AGENDA ITEM SUMMARY / STAFF REPORT
FLORENCE PLANNING COMMISSION

ITEM TITLE: PC 23 30 DR 06 – *Twombly Hwy 101 Warehouses Design Review*

RESOLUTION PC 23 30 DR 06

**FINDINGS OF FACT
FLORENCE PLANNING COMMISSION
Exhibit "A" Draft**

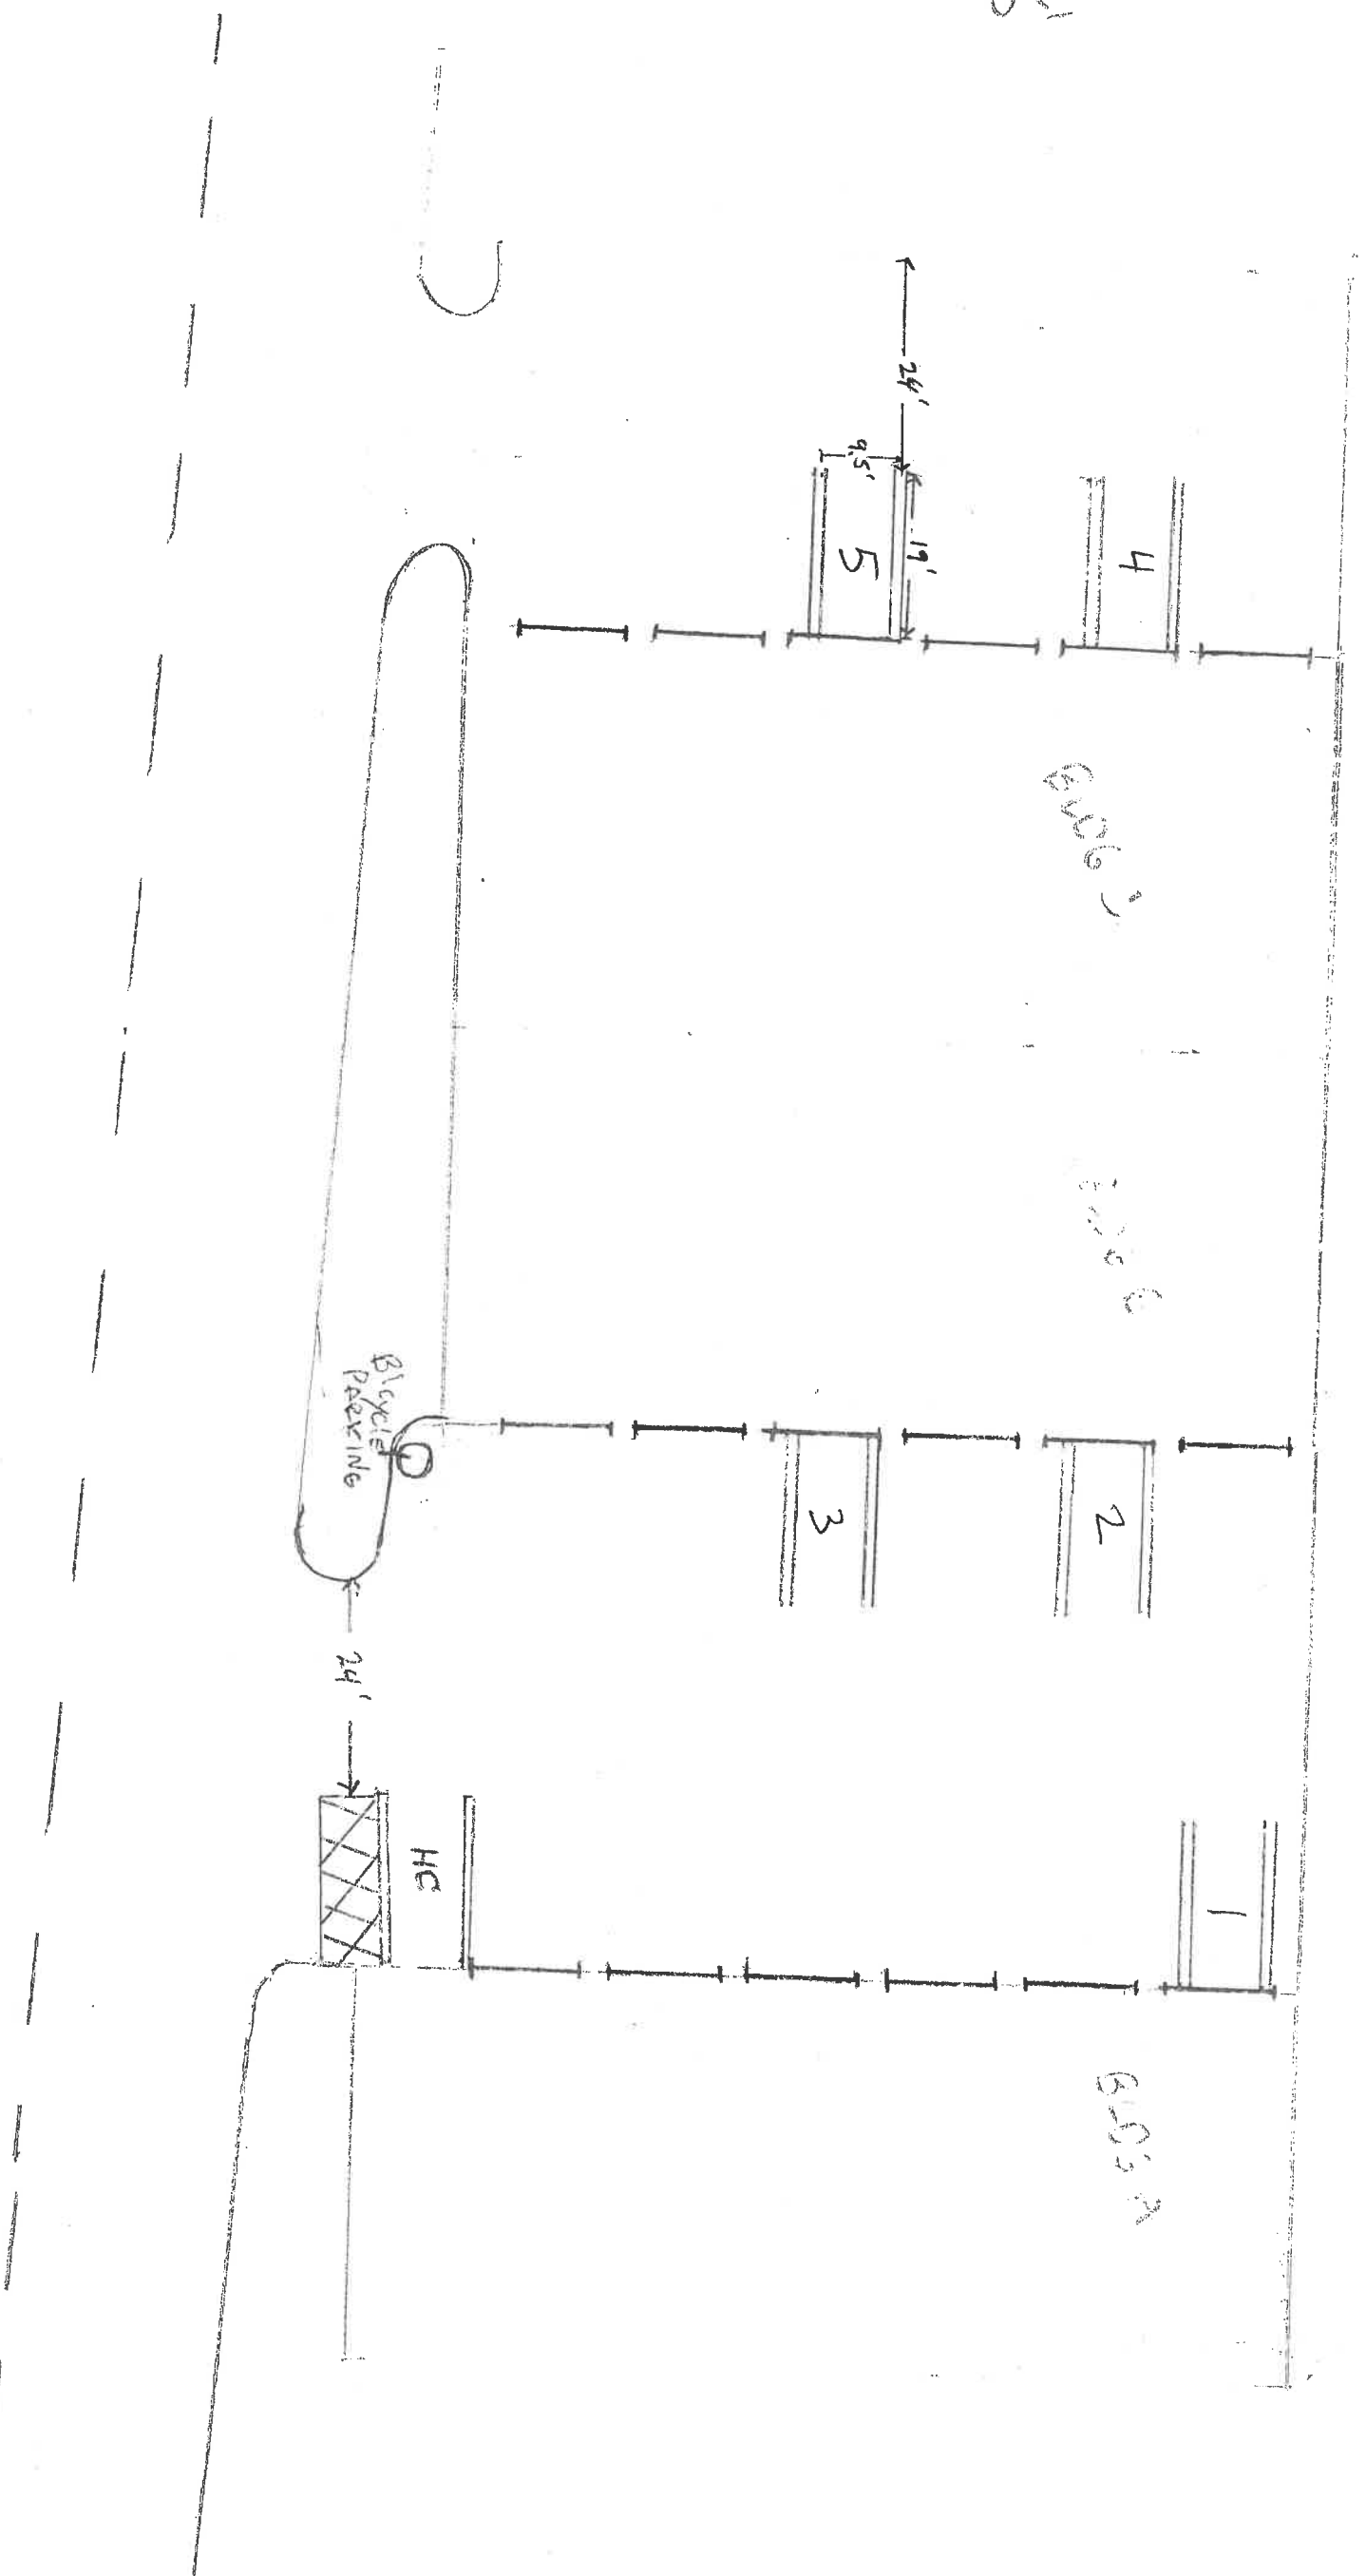
- 7-7. The ADA space and space 13 in the parking plan are adjacent and parallel to the driveway. The curbing adjacent to these spaces shall be extended along their lengths and the resulting area planted with evergreen shrubs to meet the 3' required buffer height between the space and the driveway. All landscape areas shall include ground covering.

Parking spaces are proposed as 90° head-in with all facing the warehouses. The former residential use (north of the subject lot and located in the SI zoning district), now vacant and undergoing asbestos abatement should not be affected and a future residential use cannot be replaced. An 8'-wide natural vegetated buffer will lie along the north property line area so the parking lot drive areas will be screened, nevertheless. Additionally, a 6' cedar fence is planned along the northern property line that will provide more screening. This fence will align with the parking lot between Buildings A and B.

EXHIBIT D

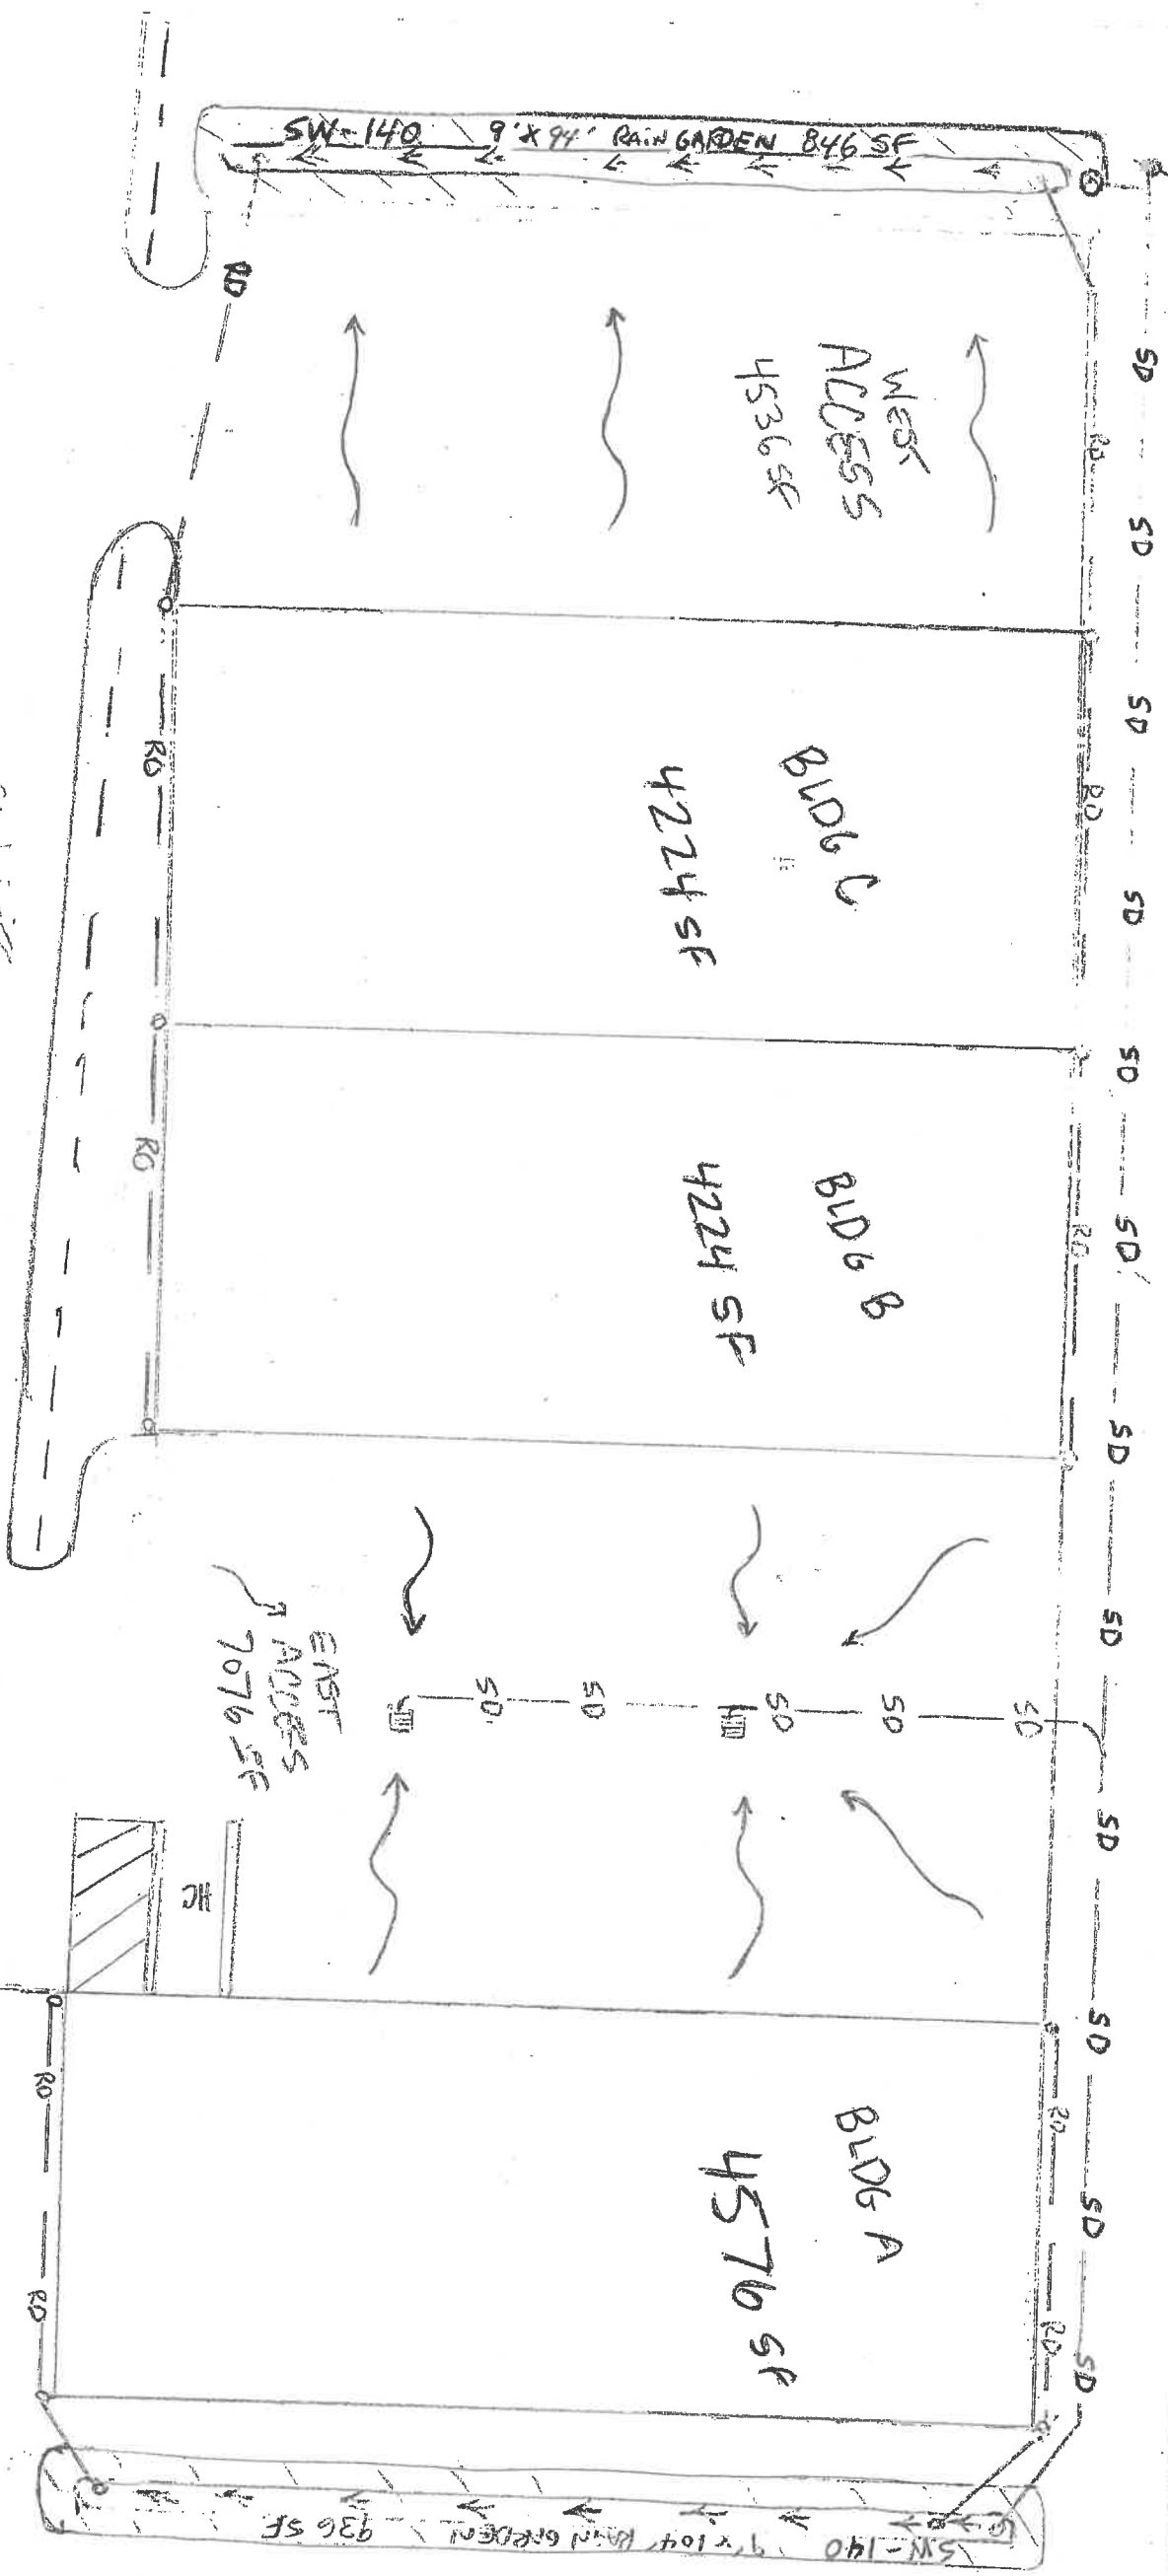
Applicant is proposing grading the development site to direct stormwater to stormwater drains within the middle of the eastern parking lot between Buildings A and B. Such drainage is proposed to flow to a stormwater facility located east of Building A. Stormwater drainage in the west parking lot adjacent to Building C is proposed to be directed westward towards a stormwater facility located immediately west of said parking lot. No stormwater is proposed to be directed towards public ROWs. Additional details of the stormwater management plan are discussed under section

According to the Service Industrial district requirements outlined in FCC 10-31-4-A through D, all setbacks, yards, height, density, and similar design features comply. The site plan (Exhibit D) indicates a 10' x 120' buffer and 9' x 104' rain garden sandwiched together abutting Highway 101. Side and rear setbacks for the Service Industrial District are 15' with exception to industrial uses abutting residential uses. The former residential use to the north is buffered by an 8' native vegetation strip and a 6' cedar fence is planned. Additionally, there is an additional 8' space between the vegetation and the building sides wherein which the storm drain line is located. The north side setback will exceed the 15' requirement. Criteria met.

Exhibit E

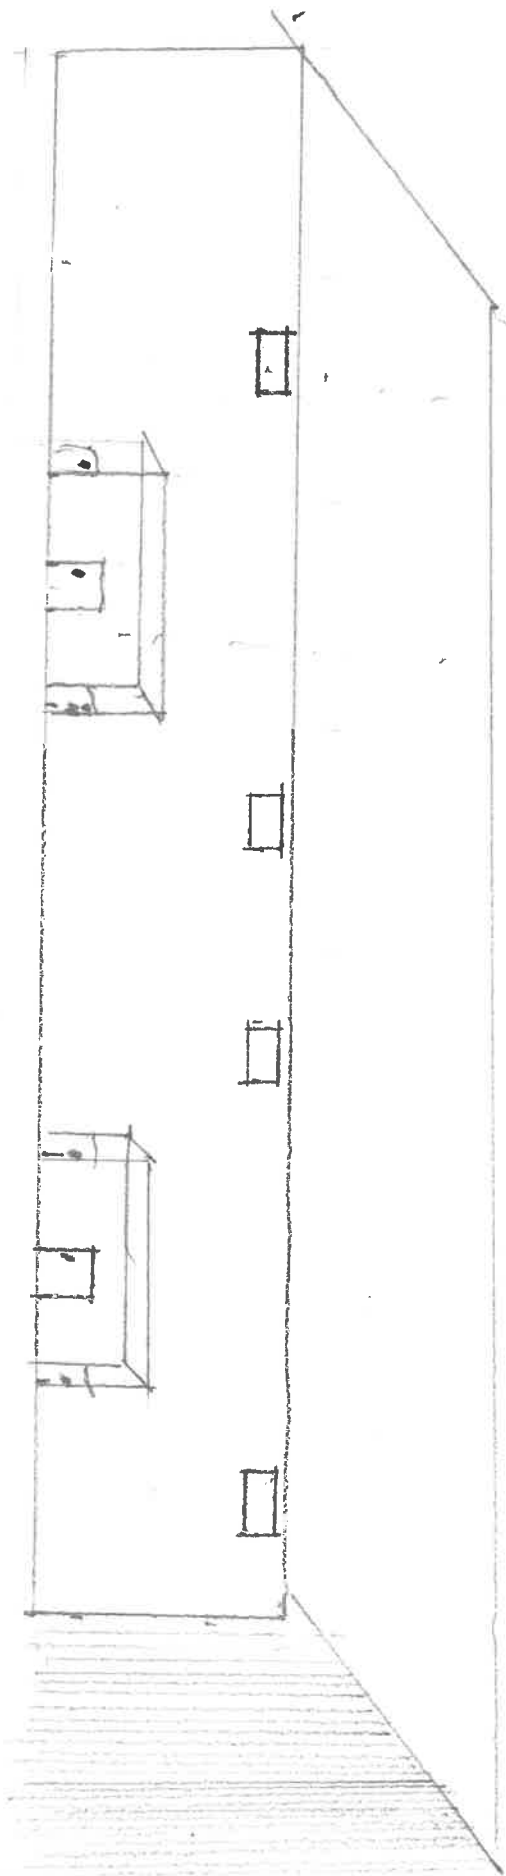
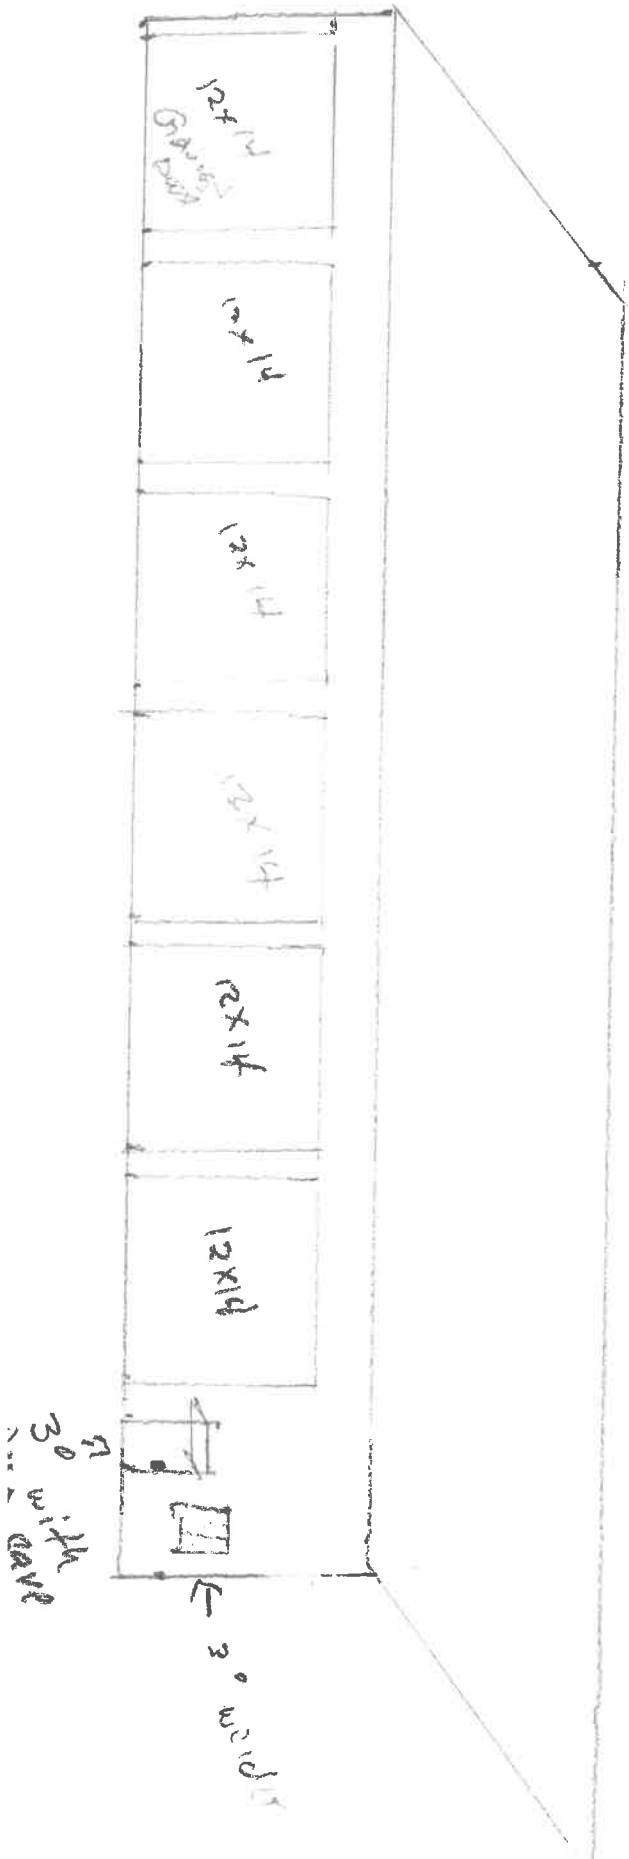
The rear of Building A is proposed to face Highway 101. The length of Building A measures 104'. The applicant proposes to construct two 4' recessed balconies with handrails above two exit doors with eave extensions (all materials unknown) as part of the articulation and detailing requirements outlined in FCC 10-6-6-3-C a, b and d, above. Four recessed windows measuring 4' in length and 2' in height are spaced throughout the length of Building A further serve to provide breaks in the wall plane. The applicant has not proposed an offset or break in roof elevation of 2 feet or greater in height as required by FCC 10-6-6-3-C-1-c. and shall submit an elevation plan meeting this requirement. [Condition 5-1]

The site plans in Exhibit E shows the 2 covered front entrances (which in practice will be rear exits but face Highway 101) of the east side of Building A will measure 4' in depth, 15' in width (including the recessed balconies), and 8 feet in height. The total elevation of this side is 15' x 104', or 1,664 sq. ft. This does not meet the minimum 6 feet in depth criteria but does exceed the 10% width of the building as the two entrances extend 14% of the width of the building elevation. Crition partially met and conditioned below.

- 5-1. The applicant has not proposed an offset or break in roof elevation of 2 feet or greater in height as required by FCC 10-6-6-3-C-1-c. and shall submit an elevation plan meeting this requirement.

- 5-2. Per FCC 10-6-7-B-1, the applicant shall submit revised elevation plans demonstrating that the covered front entrances meet the 6' depth minimum.

Per FCC 10-6-7-B-1, the applicant shall submit revised elevation plans demonstrating that the covered front entrances meet the 6' depth minimum. [Condition 5-2]
